ADDENDUM No. 1

RFP No. 23-11

Geddes Avenue and 2190 South State Street Retaining Walls

COVER SHEET

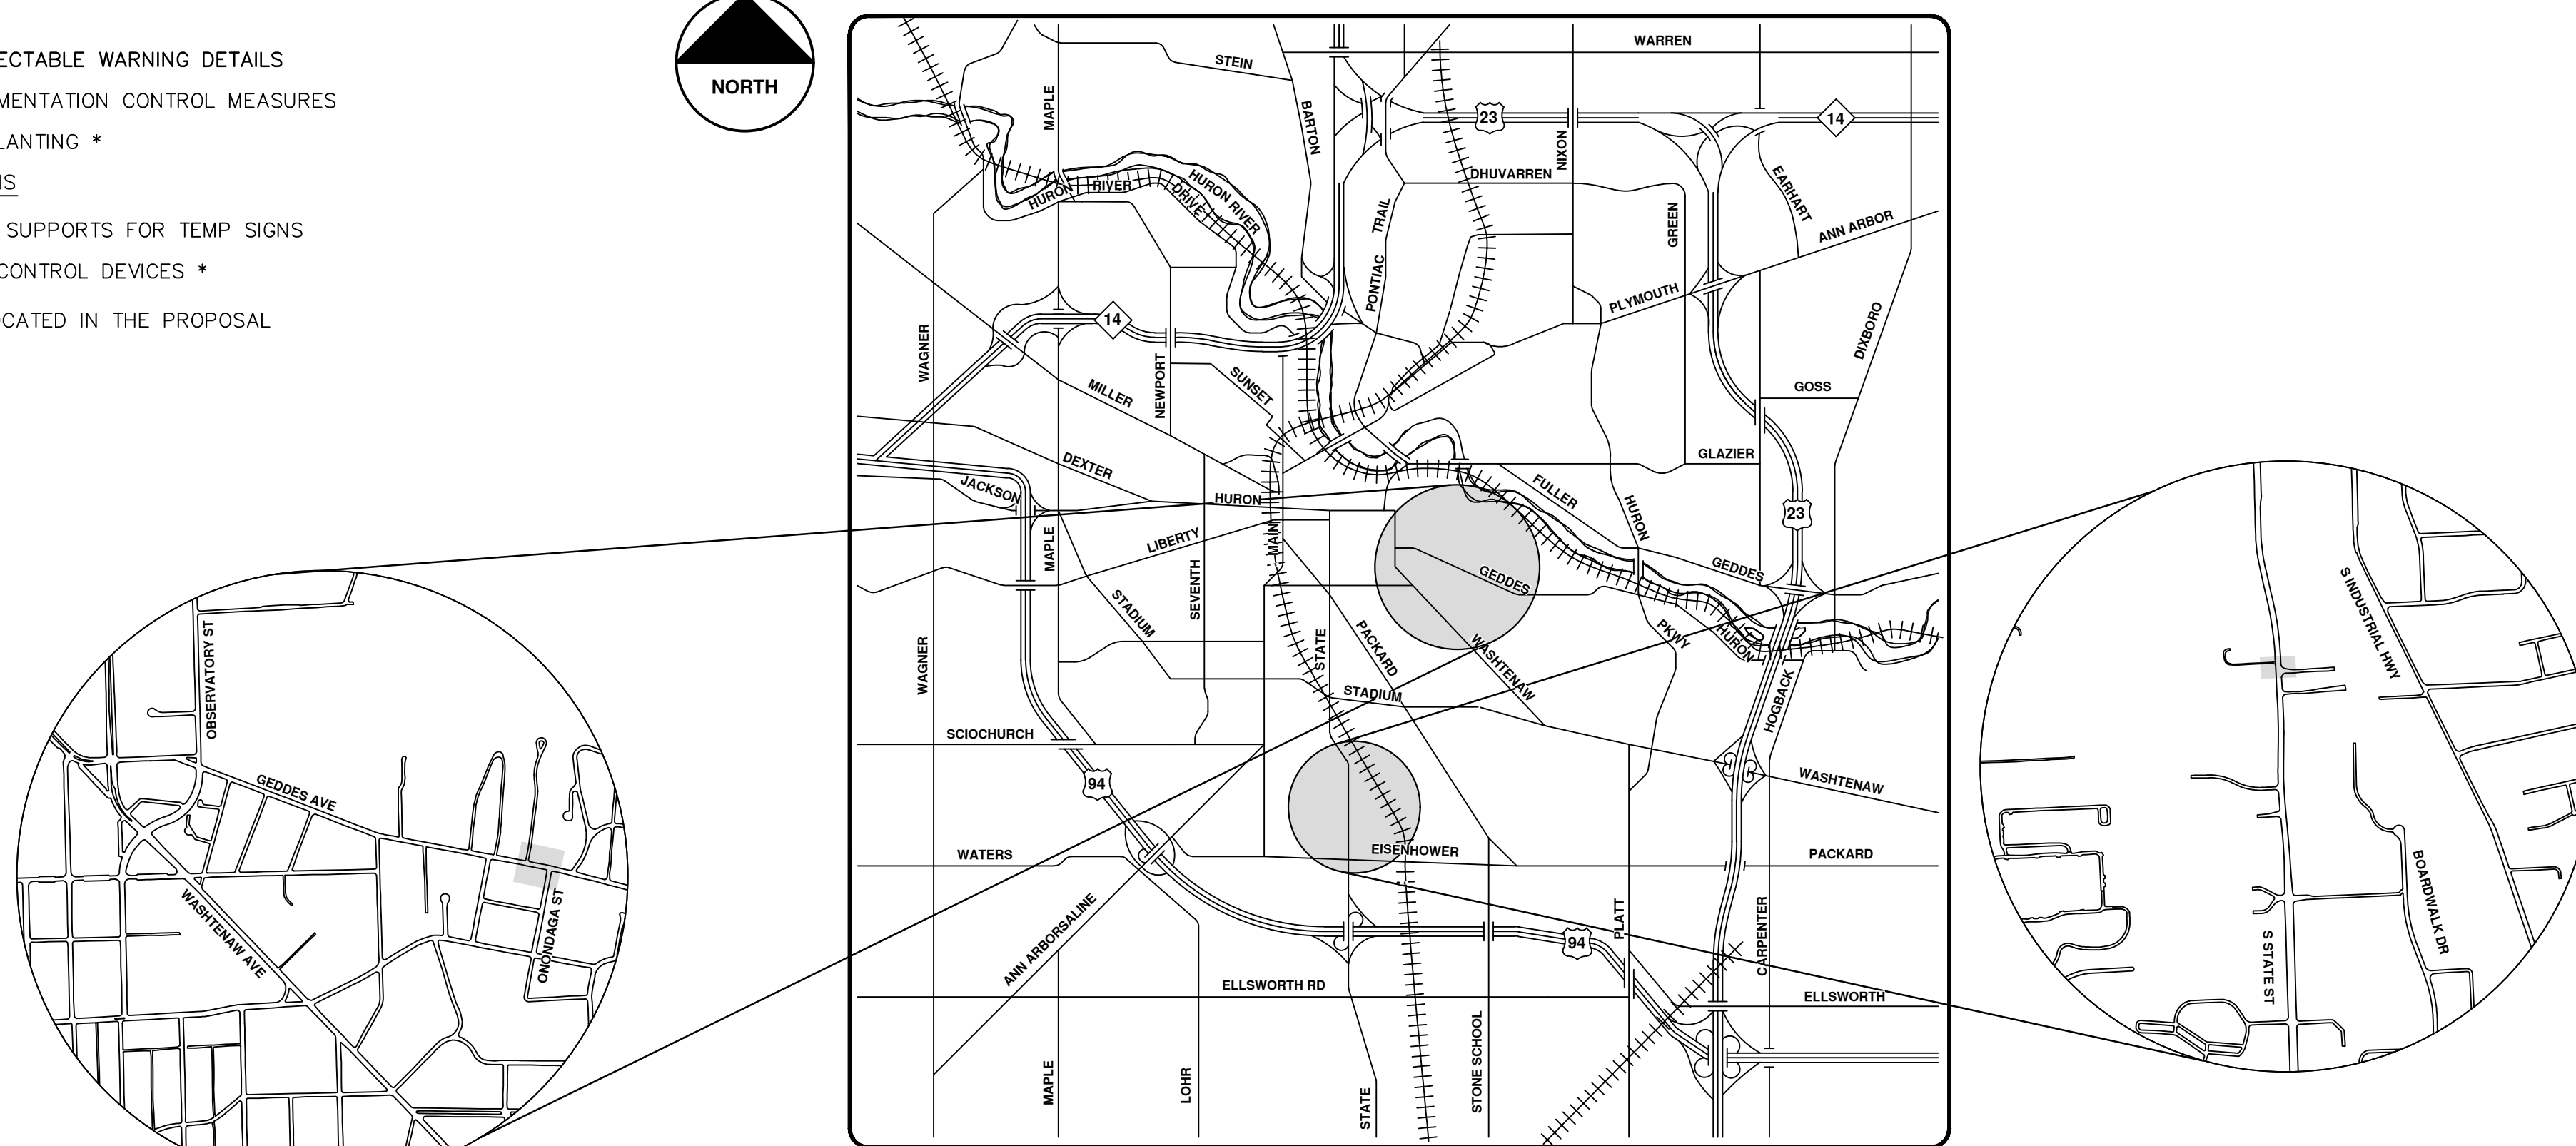
Revised “Standard Plans” “Sheet Index” tables. Completed signature/seal block.

CITY OF ANN ARBOR - PUBLIC SERVICES - ENGINEERING
GEDDES AVENUE RETAINING WALL
RETAINING WALL PLANS
RETAINING WALL DETAILS - GEDDES AVENUE

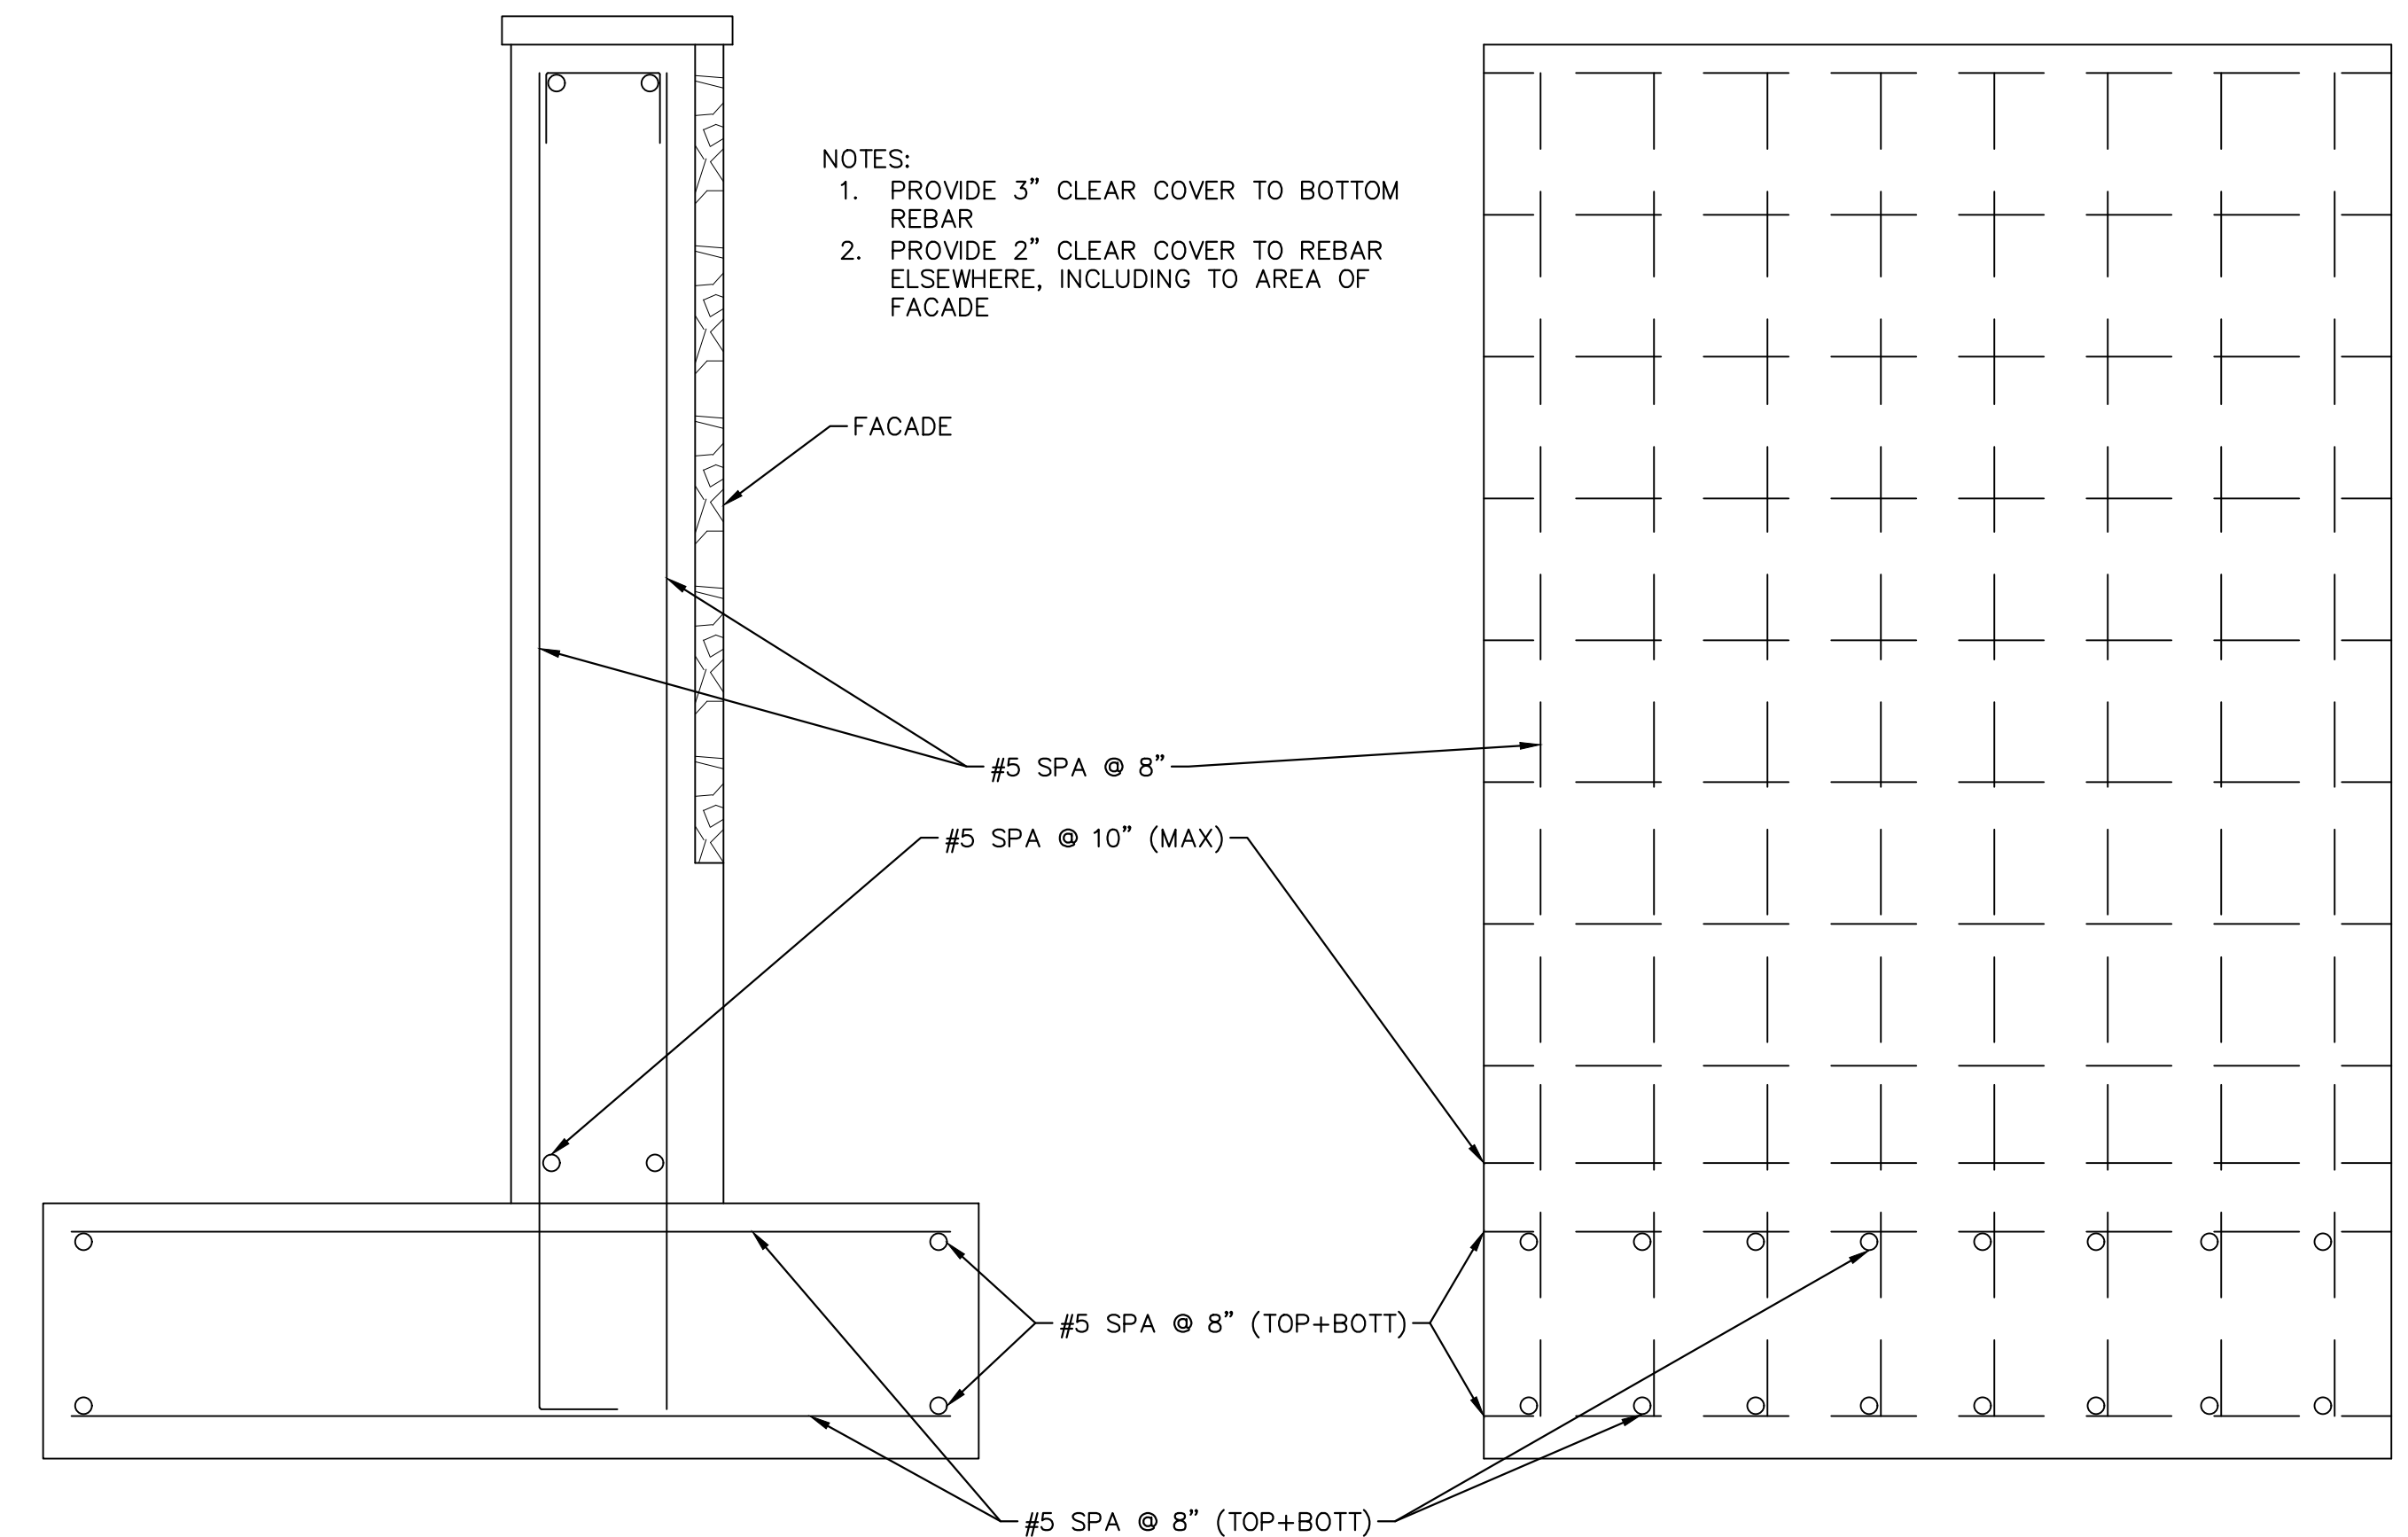
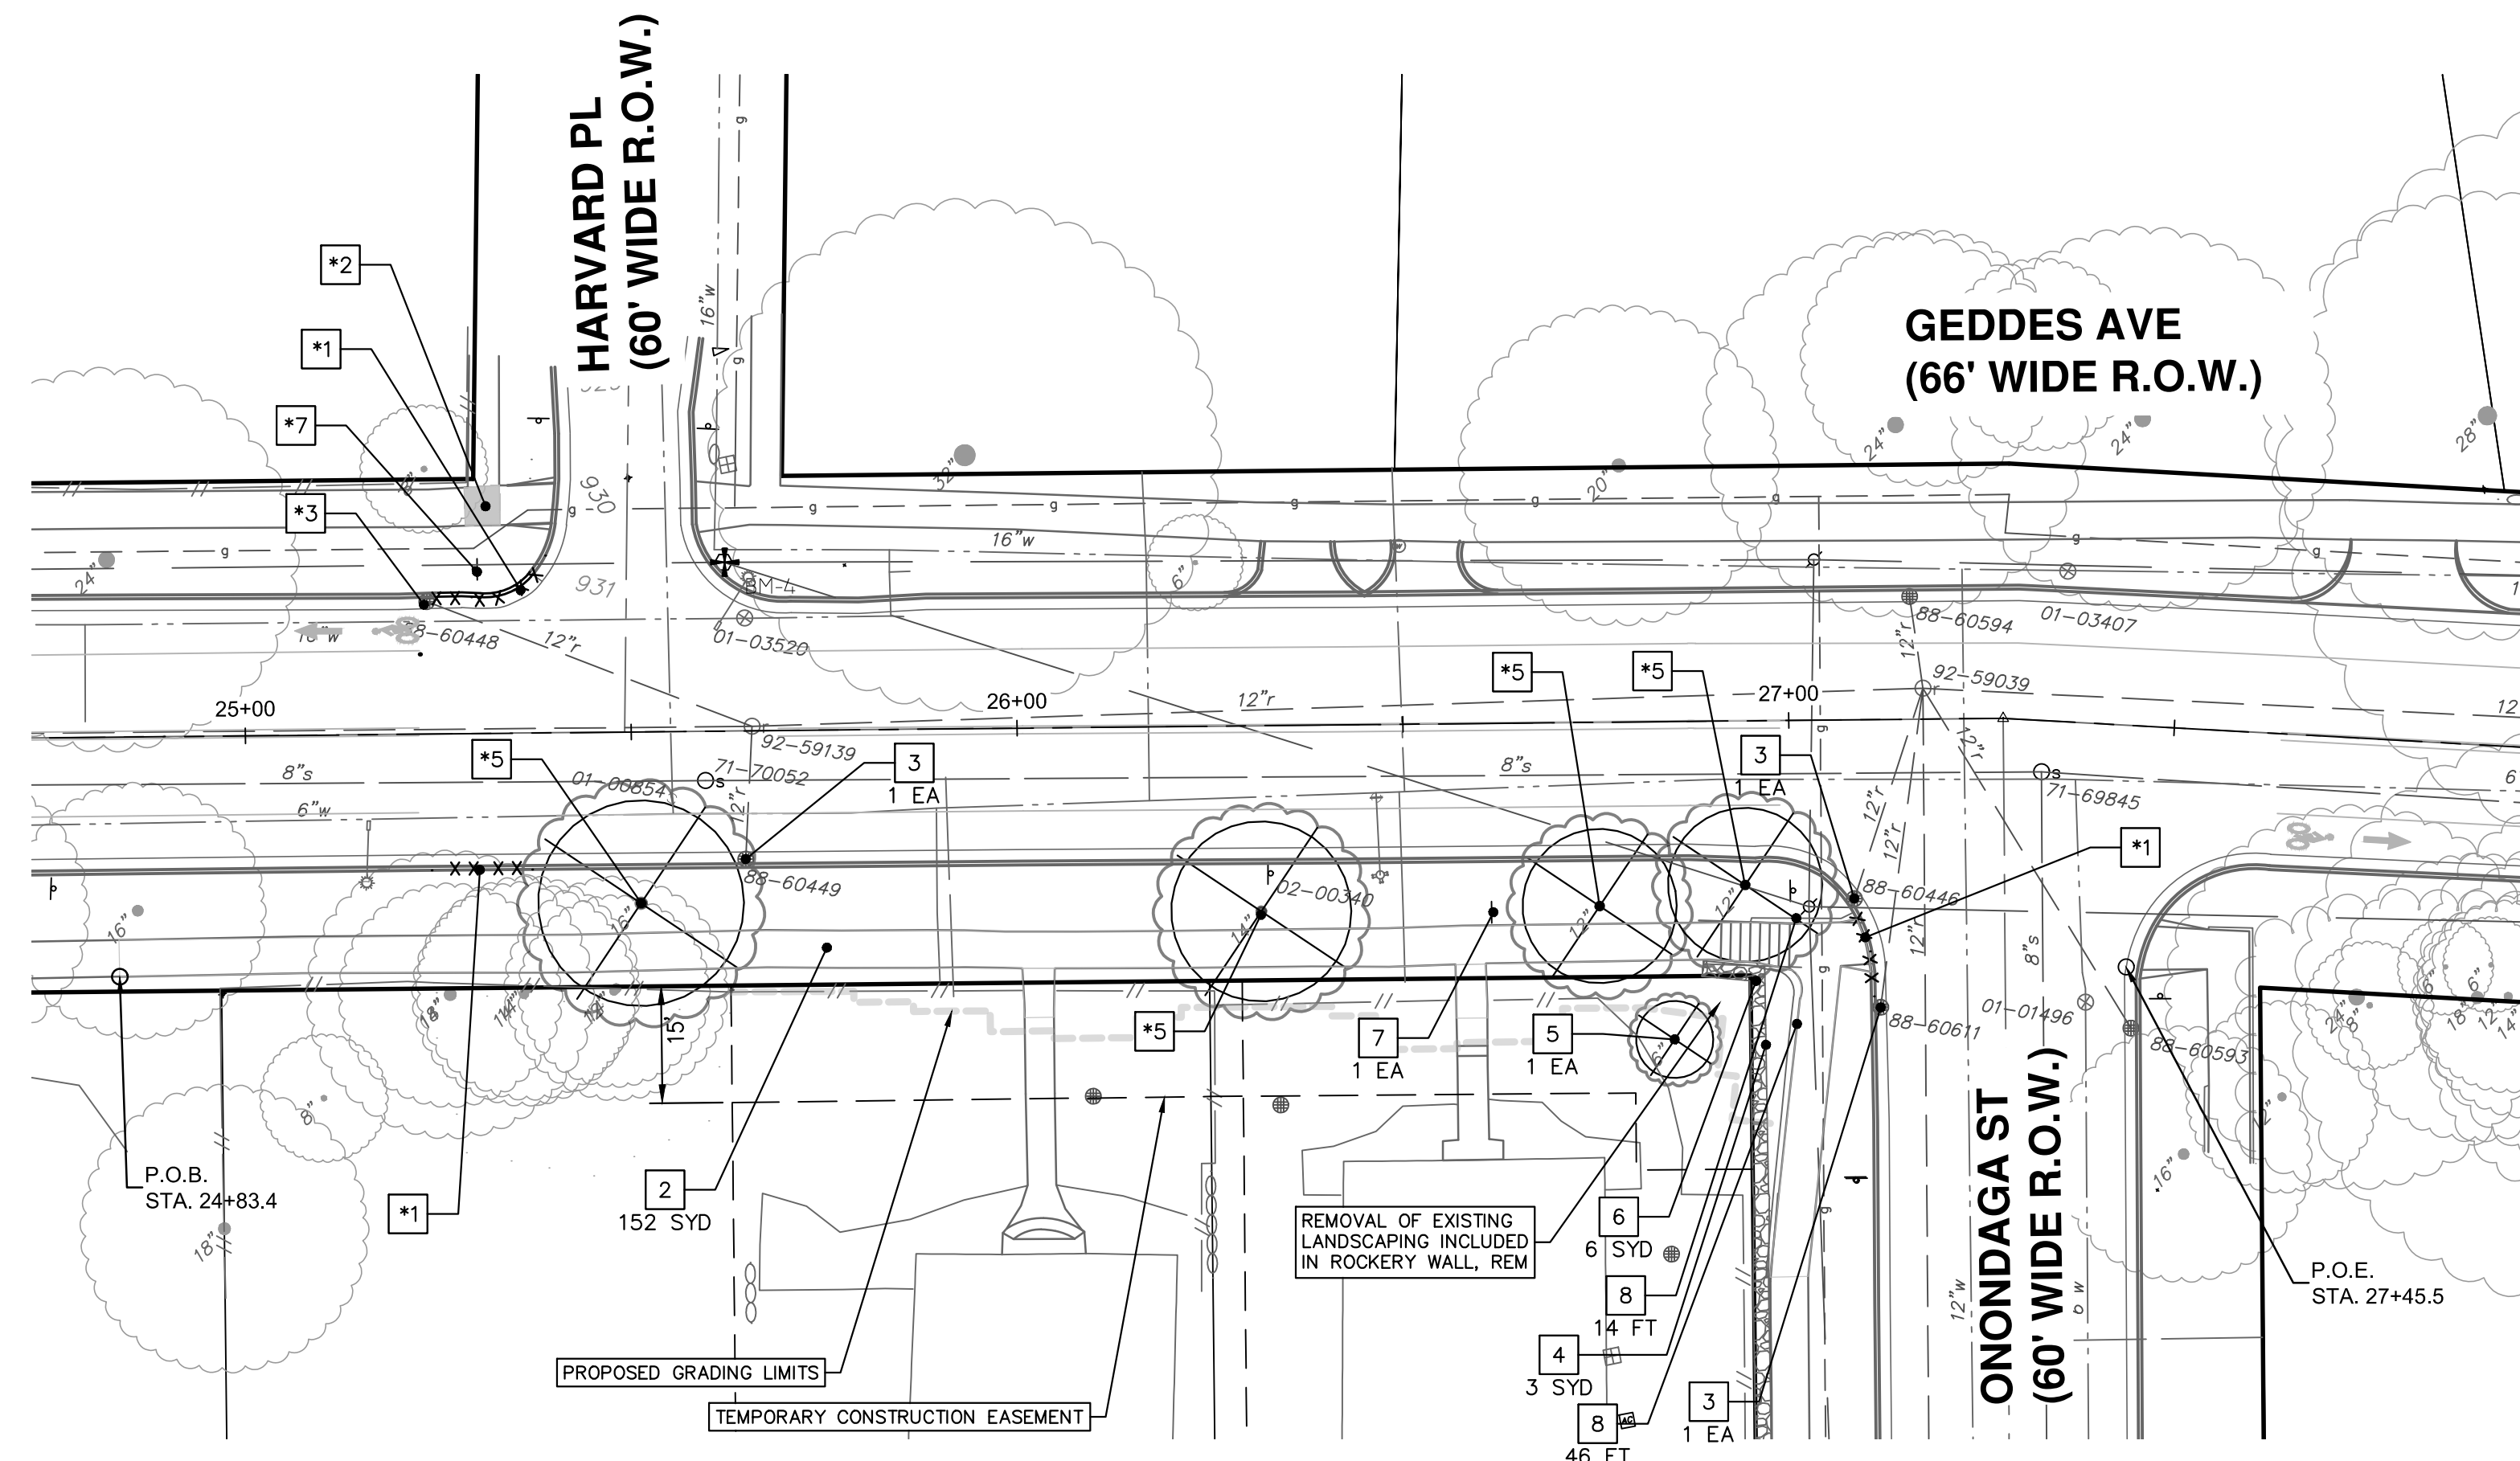
Sheet 4	Revised call outs on the “Wall Section View” detail. Revised “Wall Section View” and “Wall Reinforcement Section” details to show a flat wall cap. Revised “Sidewalk Construction Notes”.
